UT to Town Creek Restoration Project – Option A Final Monitoring Report/Closeout Report

DMS Project ID Number – 94648; NC DEQ Contract No. 003277

Submission Date: January 2021

Subject: Response to DMS Comments for DRAFT Monitoring Year 5 Report
UT to Town Creek Restoration Project – Option A
Yadkin River Basin – CU# 03040105 – Stanly County, NC
NCDMS Project ID No. 94648; NCDEQ Contract No. 003277

*BHR = 0.8 is based on as-built bkf area of 9.8 at an elevation of 565.575. Remainder of data based on actual bankfull elevation from as-built which is 565.03. Thalweg elevation is 564.298.

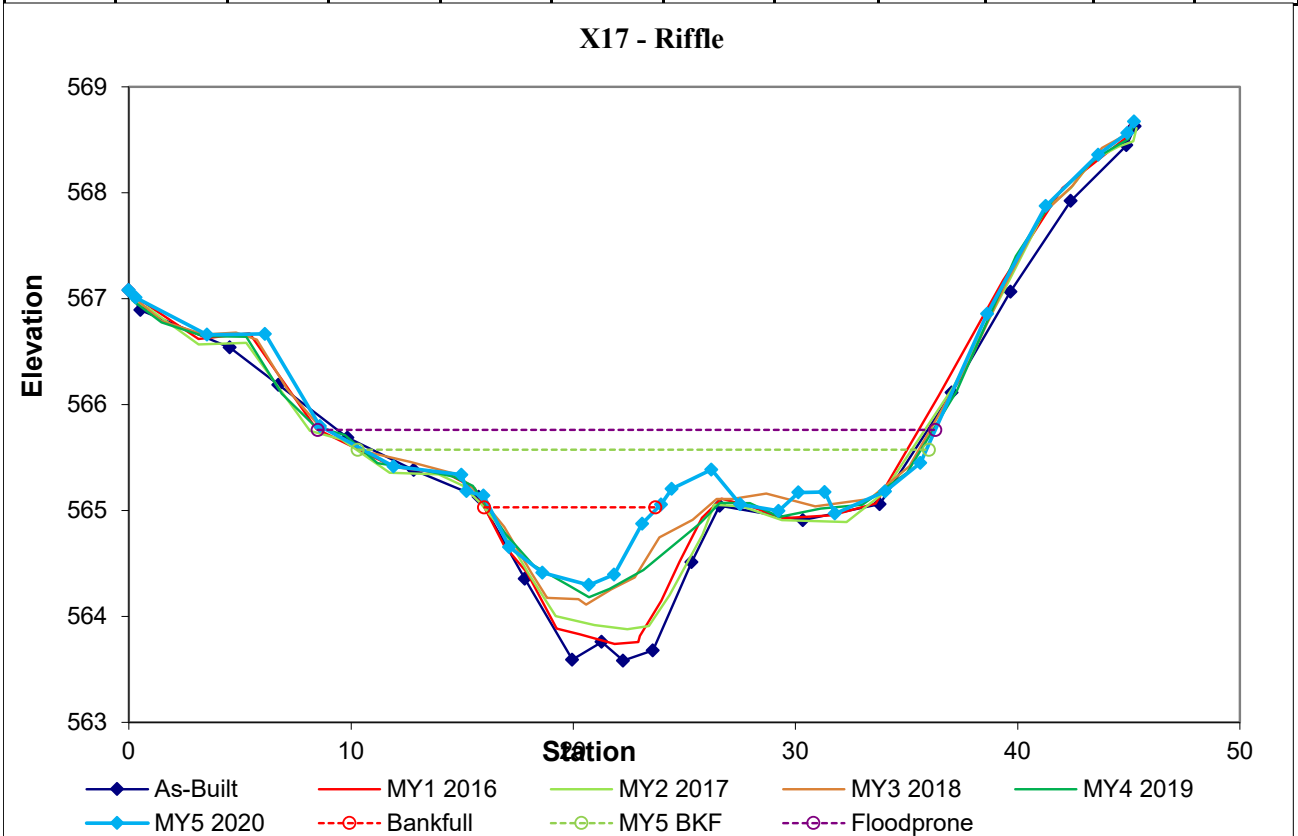
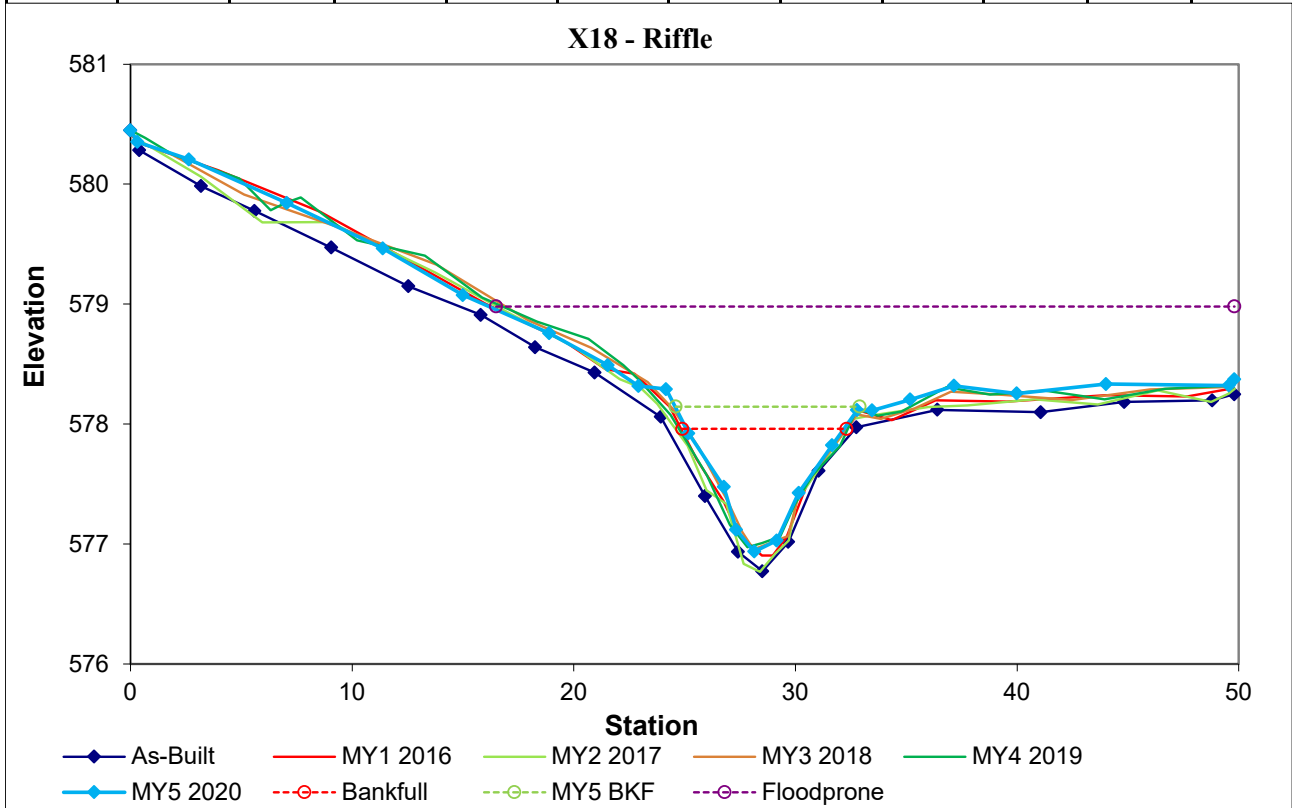
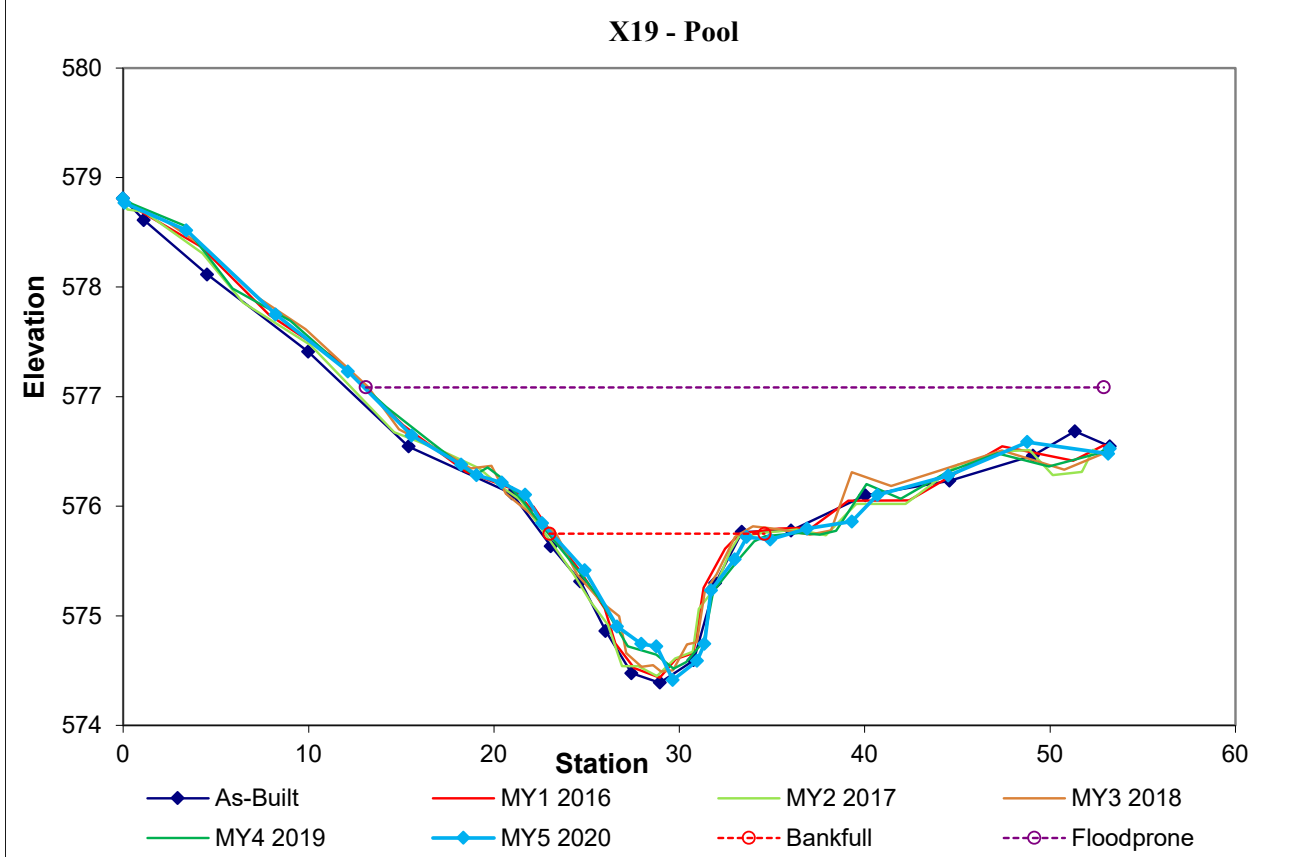
- *Please be sure that all cross section calculations are using MY5 data, and verify that the data being used in the BHR calculations are accurate. For example, it appears that XS 1 is still using MY4 data based on cell N29, while the XS 13 LTOB is listed as 565.3, but it is 565.057. The BHR calculations should be using the current monitoring year's low top of bank depth in the numerator, and in the denominator the depth at the elevation that achieves the MY0 cross sectional area in the MY5 channel should be used.*

Response: Revisions have been made to figure 3 and table 11a and 11b per DMS request.
